TECHNICAL BULLETIN

DATE: 12-15-08
NUMBER: TB-08-008

Adjustment of 5100 Bottom Weatherstrip

6100 / 8100 Cover Mounting / Support Bracket

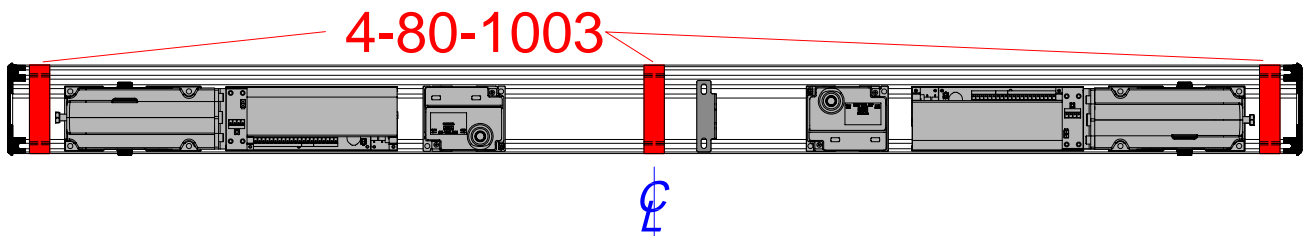
The 6100 / 8100 swing door systems now offer a mounting / support bracket for cover installation and attachment. This bracket allows the cover to be secured on all three sides in the event the ends of the cover are not accessible due to an adjacent wall or obstruction.

All dual operators will be supplied with three brackets mounted as shown below, one in the middle and one at each end. These brackets will make cover installation and removal easier.

Series 6100 / 8100 alternate ON / OFF / HOLD OPEN switch locations

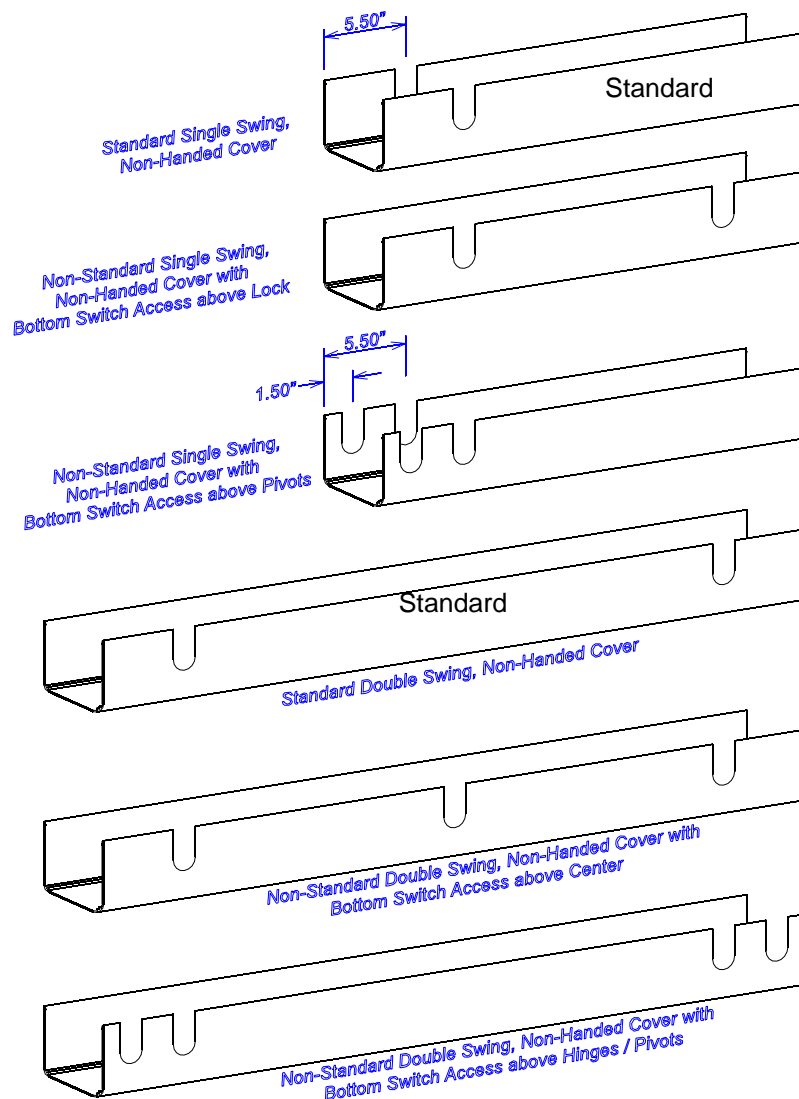
The standard location for the on/off/hold open switch is in the end cap which in some instances isn't accessible due to adjacent walls. A typical example of this situation is hospital corridor installations. To accommodate these applications record-usa can offer alternate switch locations as detailed below for a \$100.00 net add for single or dual, just provide us the desired switch location when placing your order.

ENCODER HARNESS & CONNECTOR CHANGES

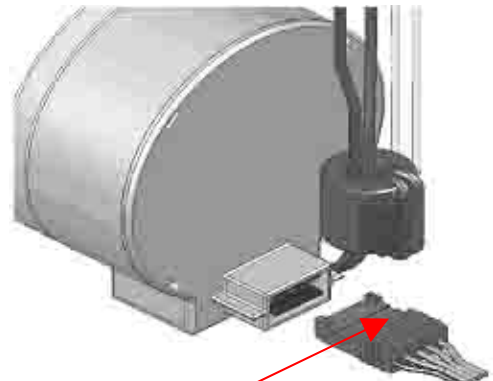
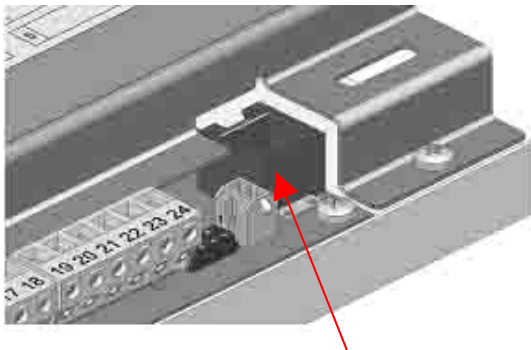
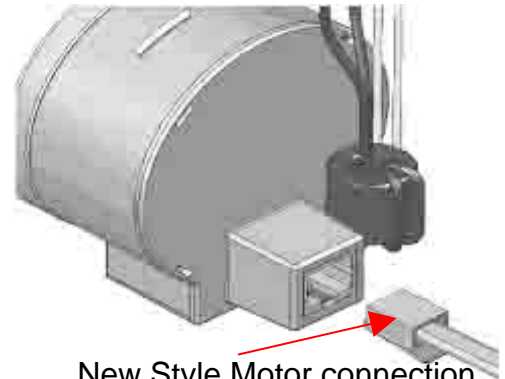
The Series 6100 and 8100 Swing Door Operator Systems now incorporate a more rugged connector configuration which should reduce the number of damaged control and encoder circuit boards. Additionally, an adaptor harness is available so that either the new control will connect to the old motor or a new motor will connect to the old control.

9-80-0016 Encoder Adaptor Harness

Series 5100 Anti-rise / Anti-derail Roller Assembly Upgrade

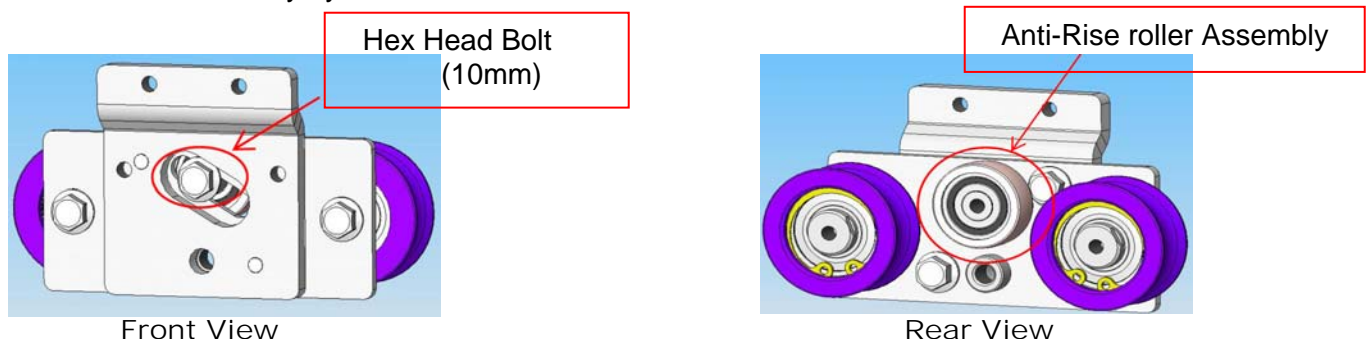
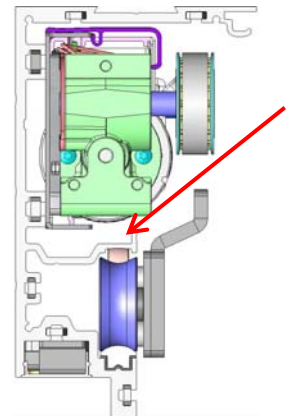
The Series 5100 upper carrier assemblies include an Anti-rise / Anti-derail roller assembly highlighted in the illustrations below. The 9-51-0003 roller assembly, identified by a black plastic "tire", has been replaced by the 4-51-0021 assembly, identified by the white plastic roller. The rollers are directly interchangeable and mounted to the carrier assembly by the same 10mm Hex Washer Head bolt.

5. Remove the 9-51-0003 assembly (black tire) and replace with the 4-51-0021 assembly (white roller). Note the flat chamfers on the roller axle should fit in the slot on the carrier assembly plate.

6. Re-install the carrier assembly on the track and adjust the new roller assembly toward the upper end of the slot such that the wheel lightly rolls against the aluminum header extrusion. Tighten the 10mm bolt securely in place.
